Our ref: 2023/5231/PRE

Re: Pre-app enquiry 2023/5231/PRE – 51 Elsworthy Road, NW3 3BS

I refer to your pre-planning application enquiry (2023/5231/PRE) for householder development at the above site, comprising a basement extension (including front and rear lightwells), removal of conservatory and erection of single storey rear extension, alteration to windows at first floor level (rear), formation of three gables at roof level (rear) and removal of garage at front and erection of a new bay window and removal of guttering pipes and a store at the front.

Proposed Basement and Lower Ground Floor Plan - 1:100 at A3

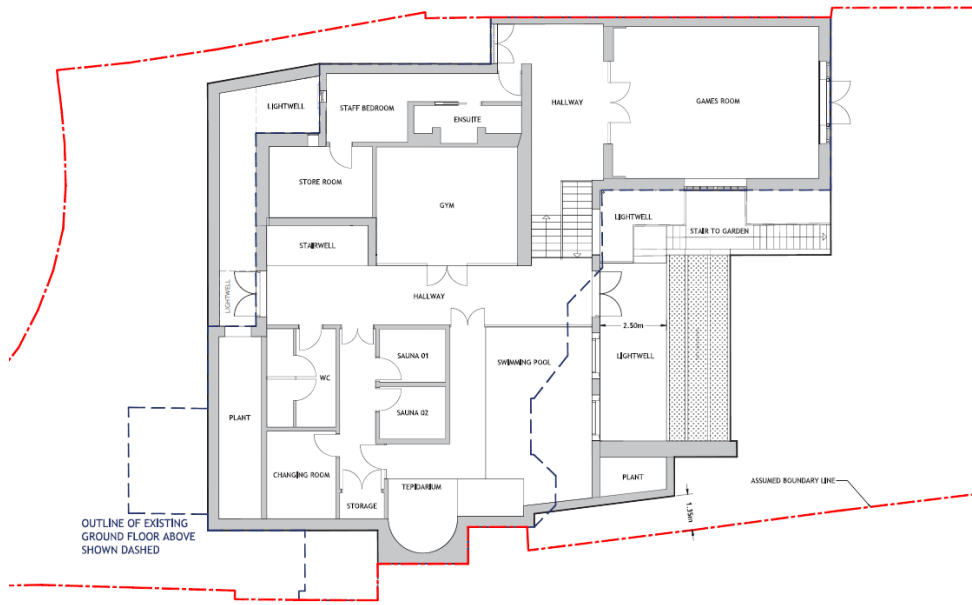
The lightwells have been amended to now form two smaller lightwells. The slight extension of the existing lightwell is acceptable as it enlarges an existing feature in a discreet location. The lightwell beside the entrance is more difficult to support because it introduces a new lightwell on a frontage, which the Conservation Area Guidelines are not in support of.

There is no concern regarding the proposed basement works providing they continue to be achievable without demolition of existing facades and result in no manifestation of any kind to the front elevation and forecourt (other than modest extension of the existing lightwell).

Proposed Rear Elevation - 1:100 at A3

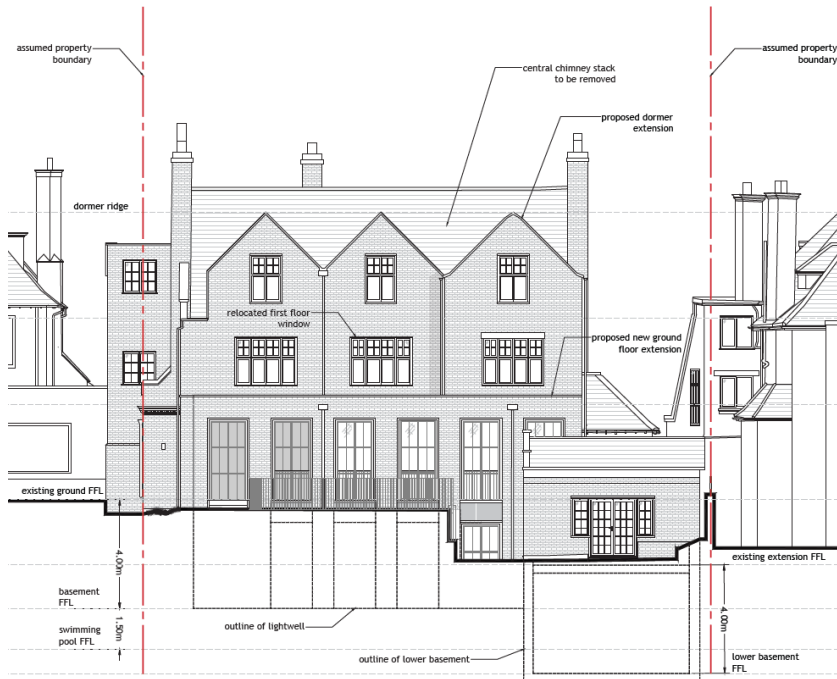
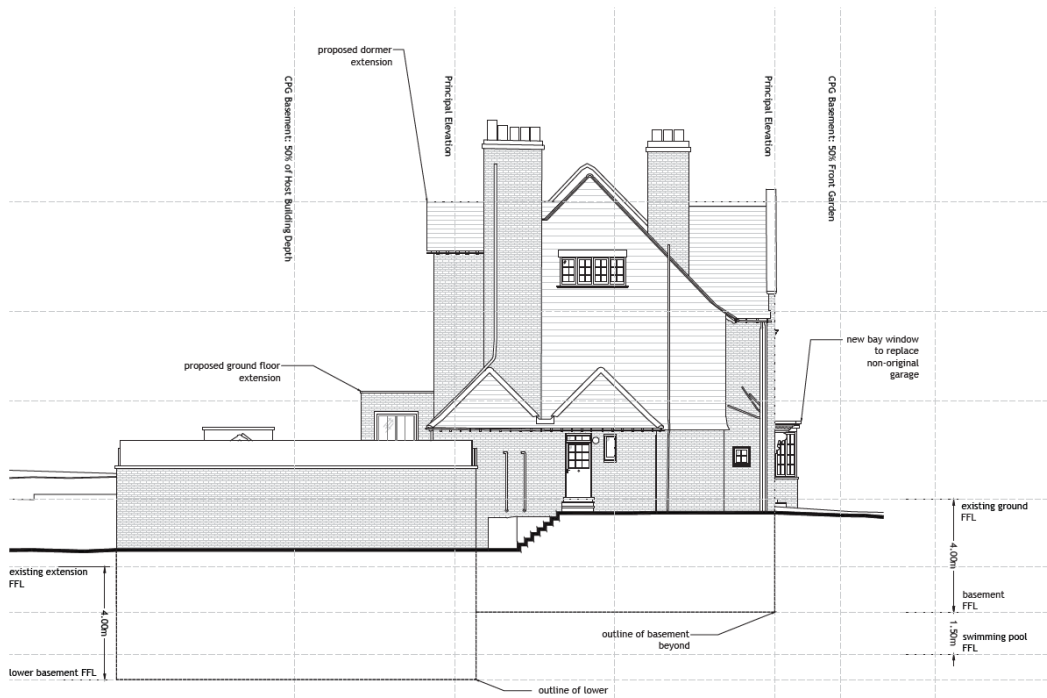
The proposed alteration of the location of the first floor windows is somewhat concerning as it does alter an historic elevation at a higher level than ground floor.

However, if the alteration to the locations of the windows can be demonstrated to be achievable without significant rebuilding of the first floor façade then it would be possible to support amendment to the positions of the window openings providing they are not of a greatly different quantity or design to the existing.

The extension of the roof to the rear, by means of gables, alters the historic form of the rear roof.

Para 13.19 of the Conservation Area Appraisal requires the retention of the many diverse historic rooflines which it is important to preserve. Fundamental changes to the roofline, insensitive alterations, poor materials, intrusive dormers, or inappropriate windows can harm the historic character of the roofscape and will not be acceptable. Of particular interest are original tiles, dormer windows, parapets, finials, chimney stacks and pots and expressed party walls.

Permission has been granted for alteration of rear roof slopes on some other properties in the vicinity. However, generally the presumption is that rear roof slopes in conservation areas should not be altered, even if they are not visible from the street. The rear roof slope of the host building is part of the historic form and design of the building and it gives integrity to the property as a piece of Edwardian architectural design. Adding three gables to serve as dormers changes the original design intent considerably and it is likely to be visible from neighbouring gardens, even if it is not visible from public land. There is no objection in principle to the loss of the existing rear dormer nor to the creation of additional dormers on the existing rear roof slope. Entirely altering the rear roof slope is more difficult to support because, even if permitted elsewhere, it harms the original character and composition of the building and runs contrary to the guidance contained in the Conservation Area Appraisal and Management Strategy

Proposed Front Elevation - 1:100 at A3

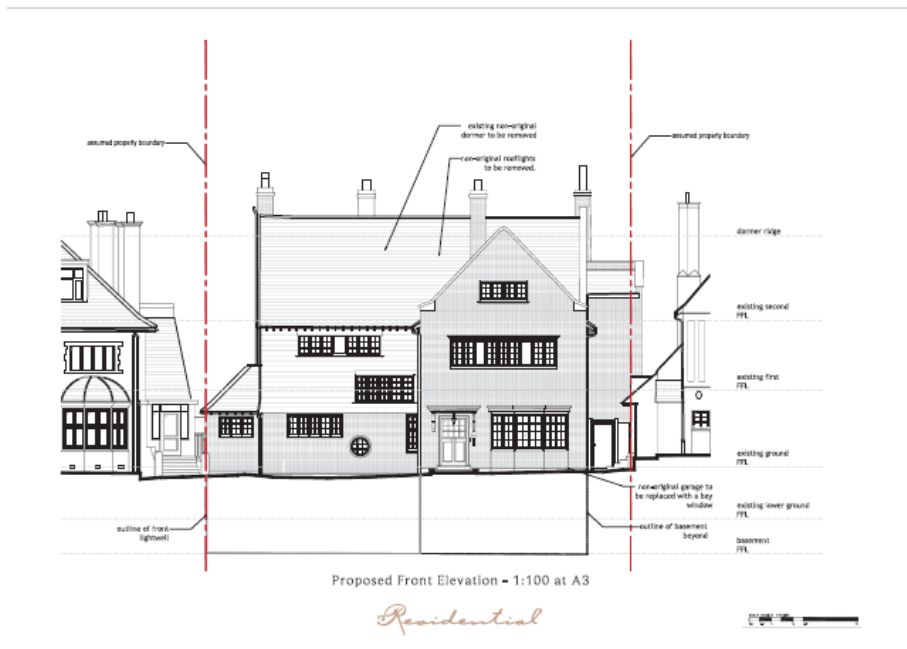
The proposed replacement of the garage with a single storey bay or bow window is considered to be an enhancement and would be supported. Other enhancements involving the “tidying up” of redundant services to the main elevations are also welcomed.
